City of Sebastopol Planning Commission Staff Report

Meeting Date: December 13, 2022
Agenda Item: 6A
To: Planning Commission
From: John Jay, Associate Planner
Subject: Preliminary Review
Recommendation: None

Applicant/Owner: Kathy Austin/Pacific Realty Development
File Number: 2022-086
Address: 7621 Healdsburg Ave
CEQA Status: To be determined
General Plan: High Density Residential/Commercial Office
Zoning: Multi-Family Residential (R7)/Office Commercial (CO)

Subject: *Preliminary Design Review & Planning Commission Review – 7621 Healdsburg Avenue – Project # 2022-086 – Mixed-use Development*

Conceptual Landscape Plan

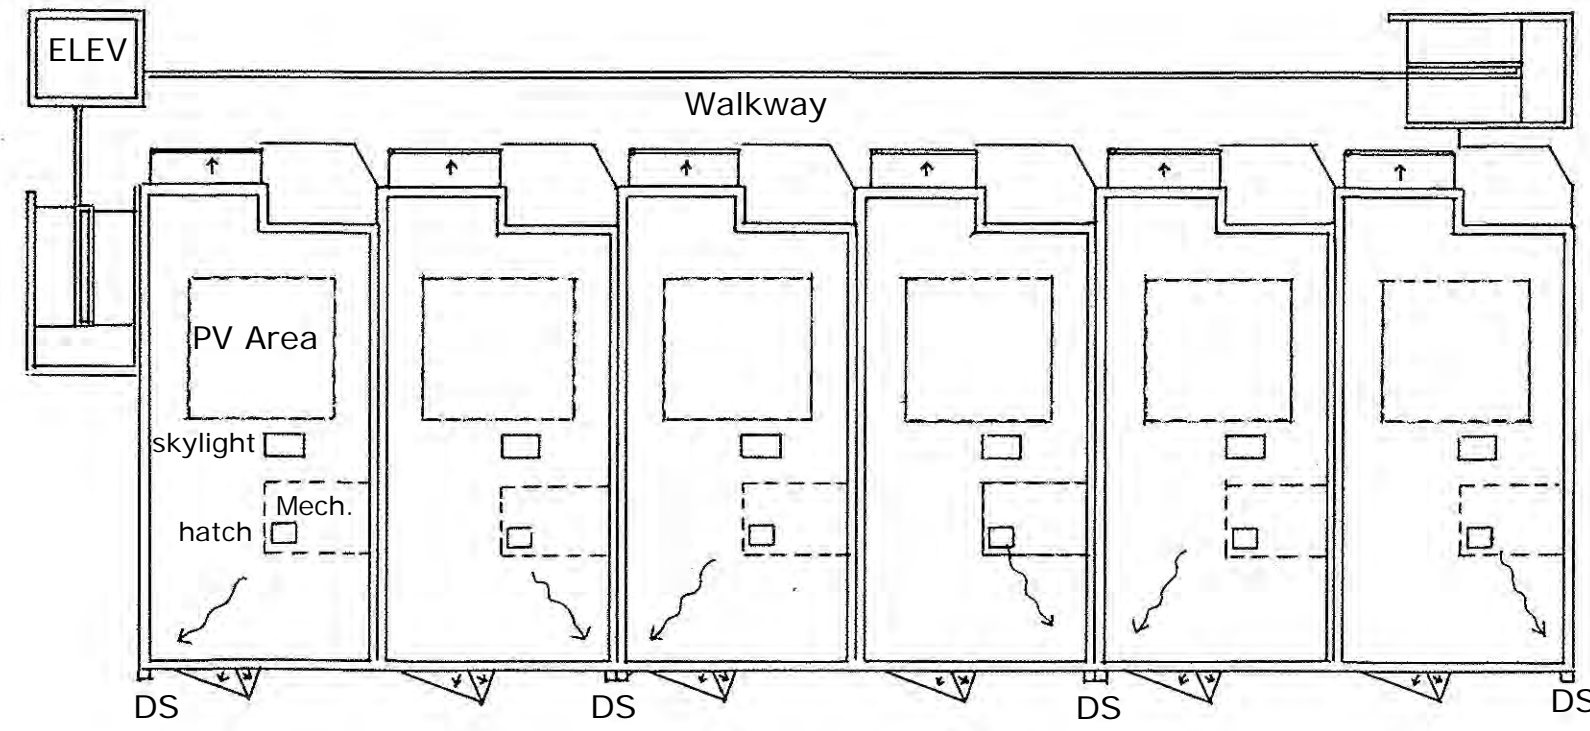
Lastly, as the site is heavily wooded with a variety of Oak trees and much of them would be slated for removal due to development impacts as noted in the arborist report. While it would be outside of the purview of the Planning Commission to provide requirements for tree removals, the Commission could recommend the applicant to revise the layout to preserve as many trees as possible.
